August 16, 2021

Comments on Draft Puget Sound Nutrient General Permit

Nutrient load action levels are too permissive

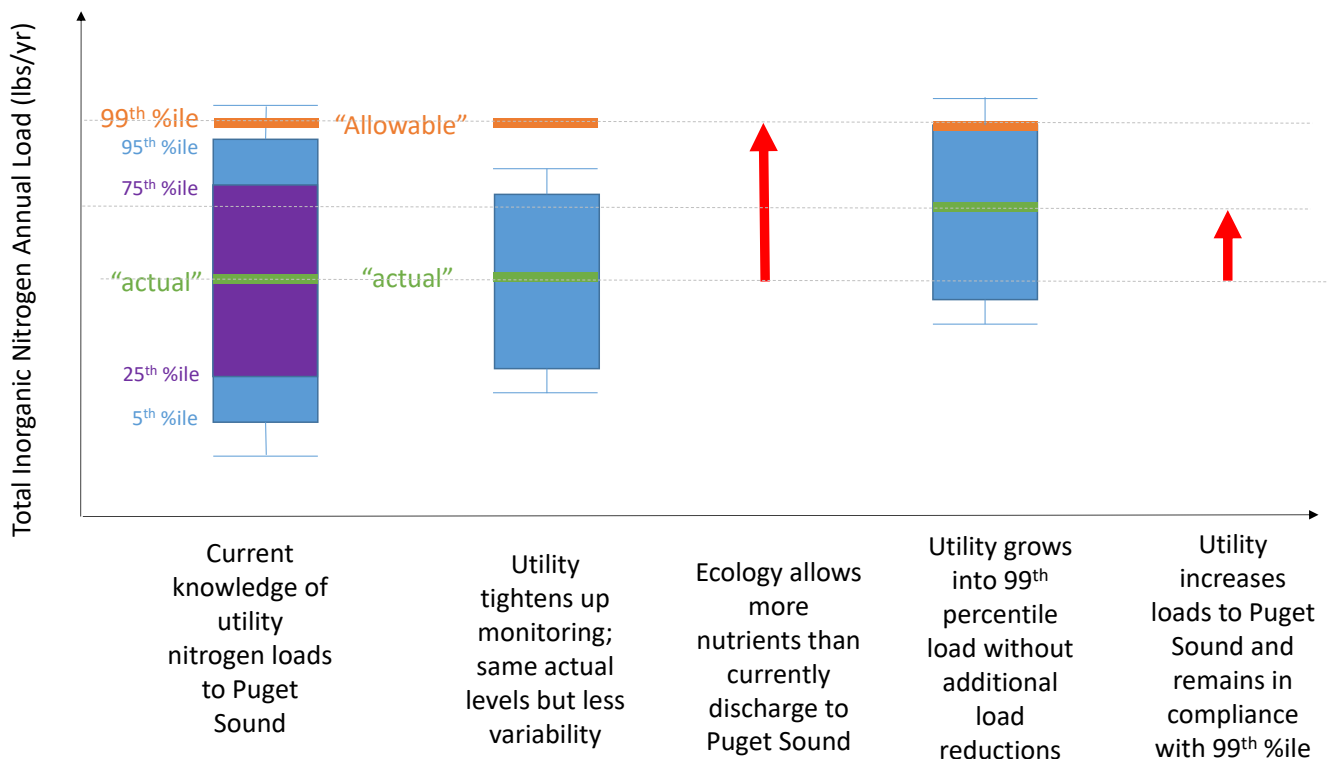
The nutrient load action levels remain far too permissive. Ecology set these at the 99th percentile upper confidence limit of current loads, even though no one advocated for this permissive of a statistic during Advisory Committee deliberations. WEC and others specifically recommended against the 99th percentile. This inadvertently allows tons of nitrogen pollution above safe levels for Puget Sound (see figure below) to protect a number that simply triggers planning activities.

We recommend that action levels be based on 75th or 90th percentiles of nitrogen load estimates by each plant.

Ecology used a statistical technique to estimate current loads from individual plants, then applied an unnecessarily permissive 99th percentile upper confidence limit for the single values listed in the Draft Permit. As described above, that inadvertently increases the allowable load to Puget Sound (see figure below). Because an overly permissive statistic was used, we are concerned that when individual plants report their annual loads as lbs/year as a single number, those are highly likely to be under the 99th percentile simply as a matter of statistics. We recommend that Ecology require plants to report annual loads as 5th, 10th, 50th, 90th, and 95th percentile load estimates rather than a single number. Dischargers have stated that they see high uncertainty in the load estimates, and reporting the ranges will improve the information available annually to assess uncertainty.
